3 August 2011
Our Ref: 6376B.29DK_mod 11

Section 75W Modification of Project Application (MP06_0058) – Modification No. 11

ATTACHMENT A

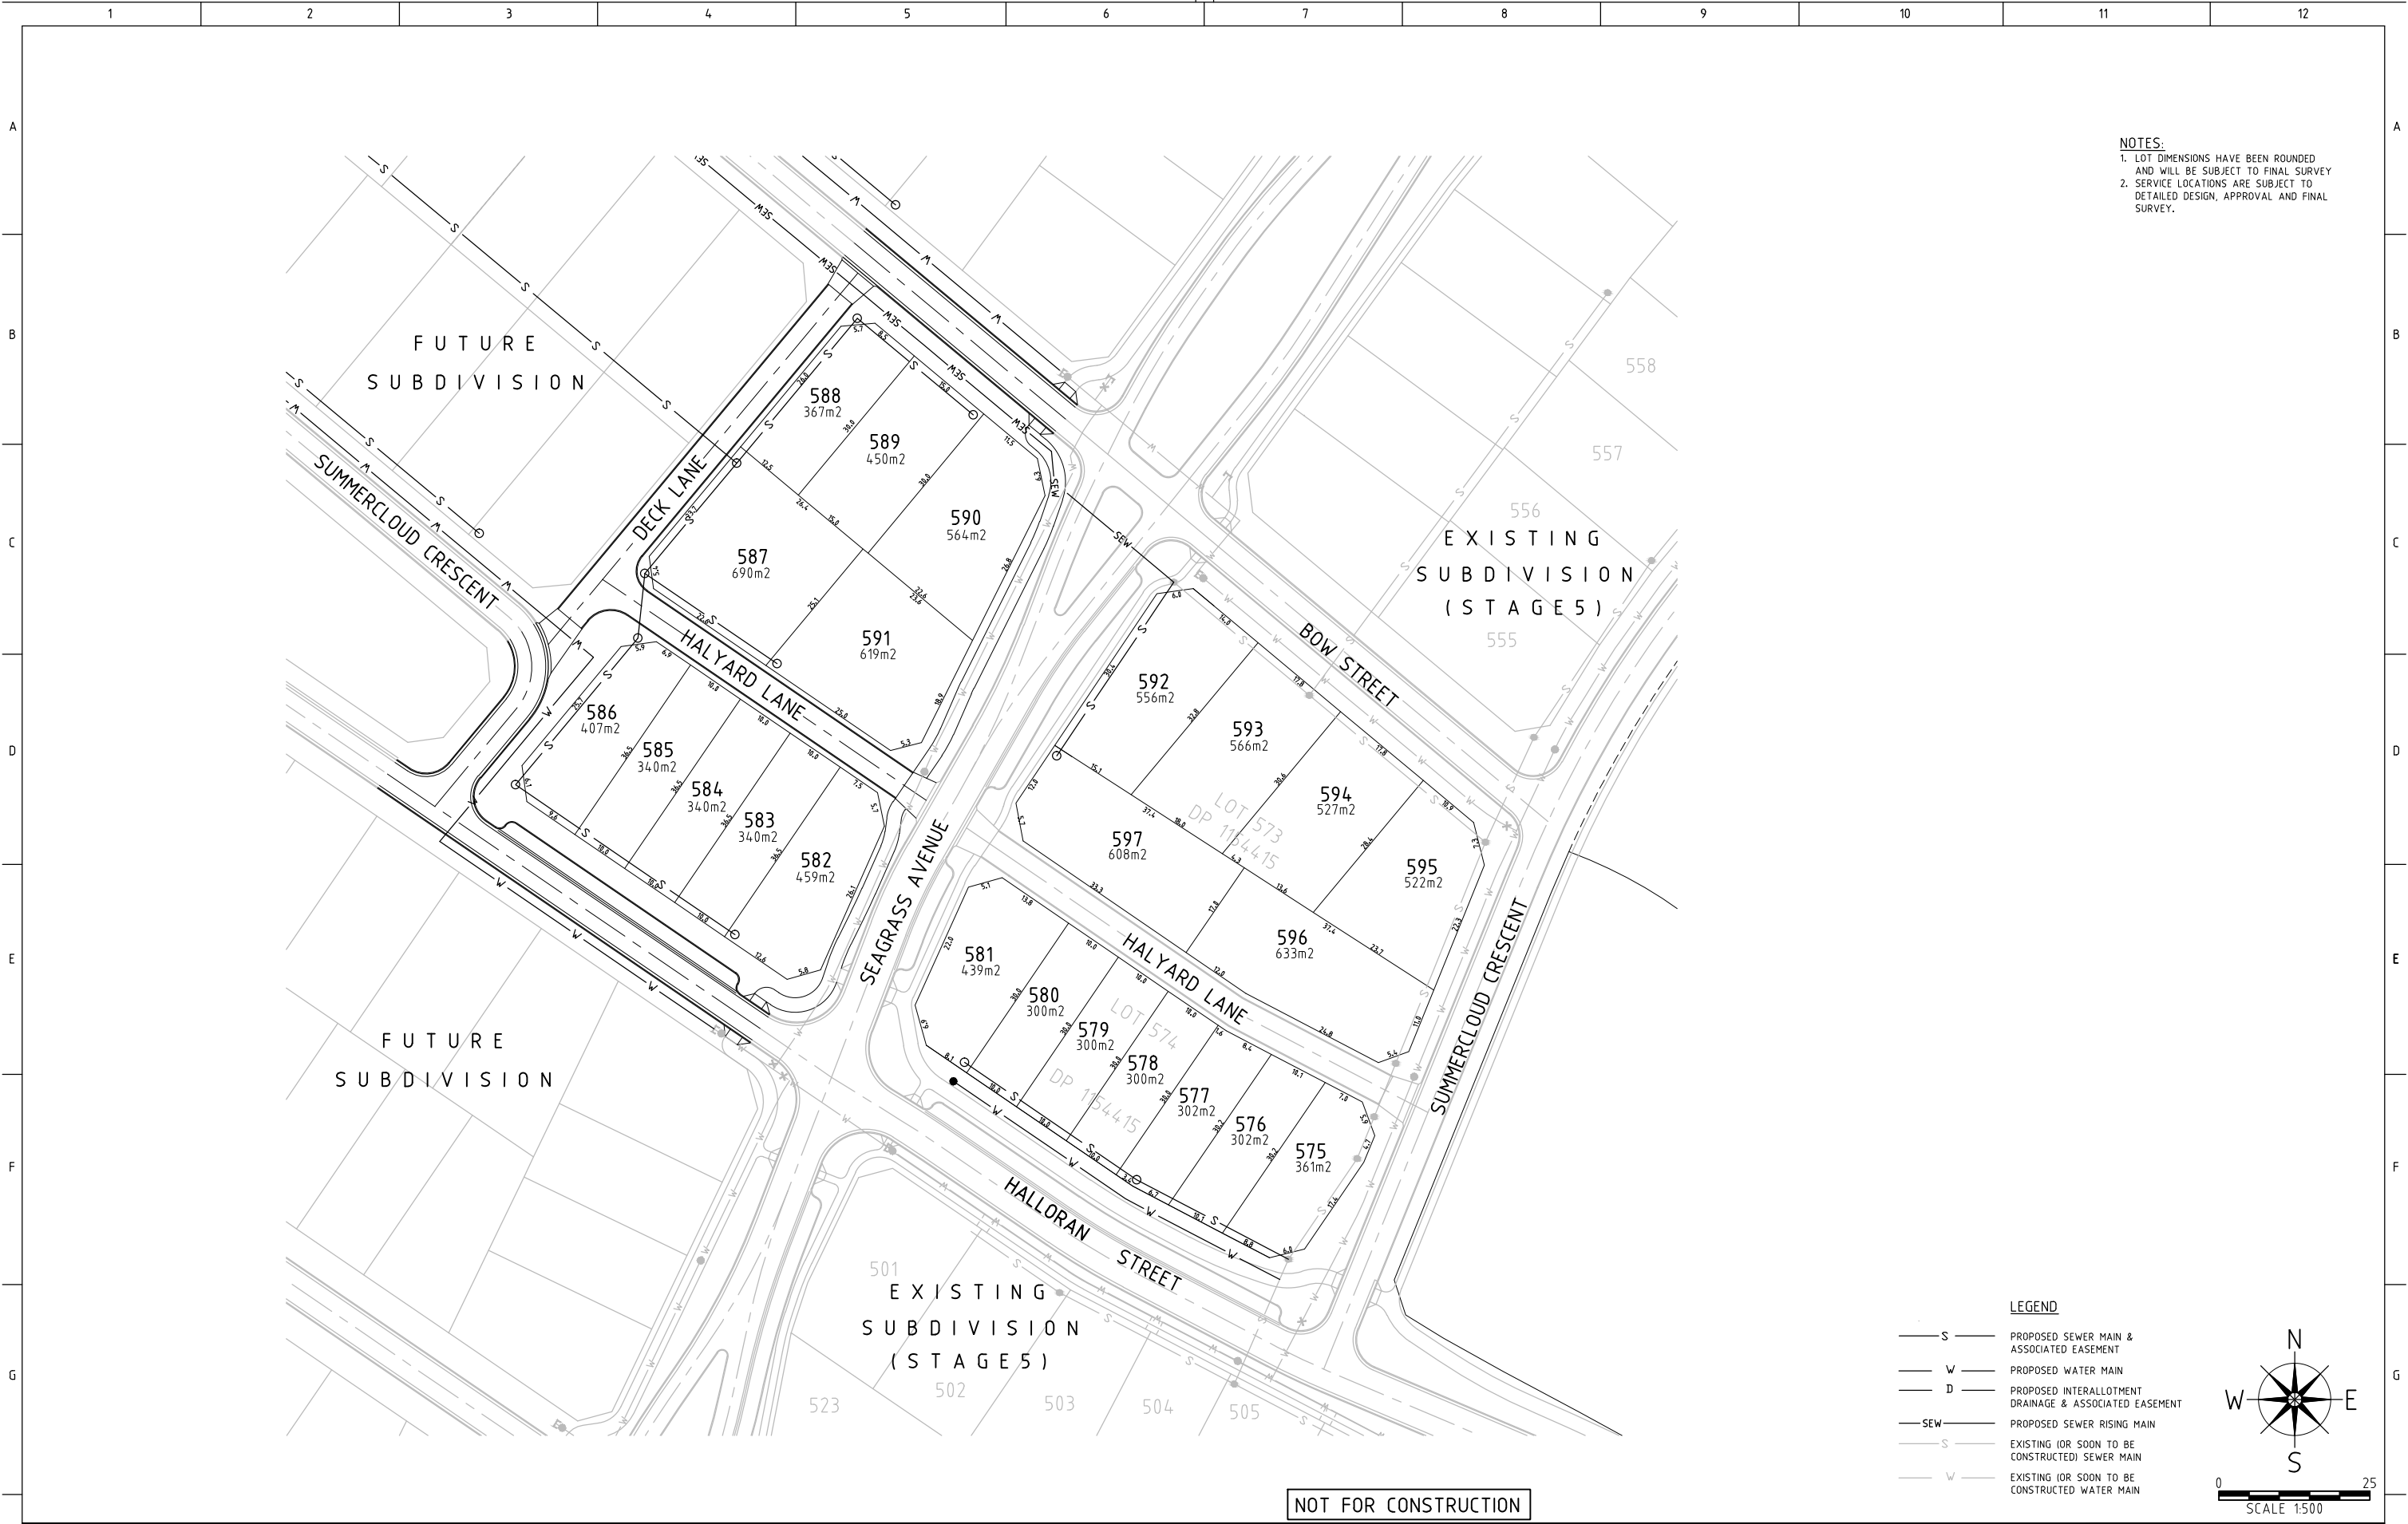
- Halloran Street outside Super lot 574 is a 'collector road' (20m wide) as shown at page 29 of the approved EAR. Halloran Street is proposed to have a typical road reserve of 20m (4.5m verge on south side, 7m pavement, 2.5m parking bay and 6m verge on northern side) not 18m as submitted by Council. The road reserve of 20m is consistent with the EAR outside Super lot 574 and complies with the EAR. No change is required to this section of Halloran Street.
- Halloran Street outside super Lot 701 is a 'local road' (16m) as shown at page 29 of the approved EAR. Halloran Street was shown to have a road reserve of 13.5m. The proposed road reserve departs from the EAR. Stockland proposes to increase the road reserve in this location to 16m consistent with the EAR. **Attachment A** illustrates this amendment. This will reduce the overall site area of super lot 701.

Council states that the 13.5m road reserve outside Super lot 701 does not have an indented car parking bay. In accordance with Statement of Commitment No. 66, this section of Halloran Street being a local road is not required to have indented car parking bays. However, as noted above, Stockland proposes to increase the road reserve width to 16m (in accordance with the approved Concept Plan) which will allow for the provision of an intended car parking bay. This arrangement is workable as the lots have frontage to Halyard Lane providing vehicular access to the proposed lots and thereby enable the provision of the indented car parking bay.

Council's Recommendation	Comment
Halloran Street road reserve be a minimum 20 m wide between Summercloud Crescent and Seagrass Avenue and minimum 18 wide between Seagrass Avenue and the n-w public reserve	<p>A 20m wide road reserve is provided between Summercloud Crescent and Seagrass Avenue and an amendment is not required.</p> <p>The 13.5m wide road reserve between Seagrass Avenue and the north-west public reserve is proposed to be increased to 16m (consistent with a local road under the approved Concept Plan).</p>
The number of lots be reduced to result in an aggregate residential yield of approximately 604 lots consistent with the Concept and Project Approval of 25 January 2007	The proposed lot yield under Modification 11 is 614 lots, or 10 lots greater than that originally approved. This is only a 1.6% increase in the approved lot yield and is considered a minor increase and consistent with the Concept Plan and Project approvals.

Proposed lot 588 be increased in size to at least 500m ² area	Council asserts that the site area lot 588 is of concern as the proposed lot is subject to additional restrictions to development. We have reviewed the General Housing Code contained in SEPP (Exempt and Complying Development Codes) 2008. This Code applies to lots of greater than 200m ² with a frontage of at least 6m. Lot 588 meets these criteria. The Code also requires (in this case) a minimum front setback to a primary road of 4.5m and minimum setback to a secondary road of 2m. Therefore the SEPP contemplates that a dwelling house could be approved as complying development on a lot such as Lot 588. To require the lot to be increased to 500m ² for reasons of being constrained or of inadequate site area is inconsistent with the State policy. Amendment to lot 588 is not considered necessary.
The number of lots as a result of the subdivision of lot 701 be reduced in number and each resultant lot be increased to at least 500m ² area	<p>The 500m² lot size is a development control contained in DCP 100. The Concept Plan has approved a lot mix with site areas ranging from less than 300m² – 500m². The lot sizes are consistent with the product diversity approved as part of the Concept Plan application.</p>

The number of lots as a result of the subdivision of lot 574 be reduced and each lot be increased to at least 500m ² area	
The proposal consider the effectiveness for vehicular access to each new lot as a result of providing a continuous indent bay to lots 574 and 701 and to identify the number of spaces available that are not impacted by vehicular access to the individual lots.	Lots 574 and 701 are provided with a second road frontage to Halyard Lane which will provide vehicular access to the proposed lots on these super lots. The indented car parking bays can be provided along Halloran Street without affecting vehicular access to the proposed lots.

An amended plan is included in **Attachment A** which incorporates two amendments including:

1. An increase in the width of the road reserve to 16m along Halloran Avenue outside super lot 701. This section of Halloran Street was nominated as a local road in the approved Concept Plan application and the proposed road reserve width of 16m is consistent with the approval.
2. The provision of an indented car parking bay along Halloran Street (adjacent to super lot 701).
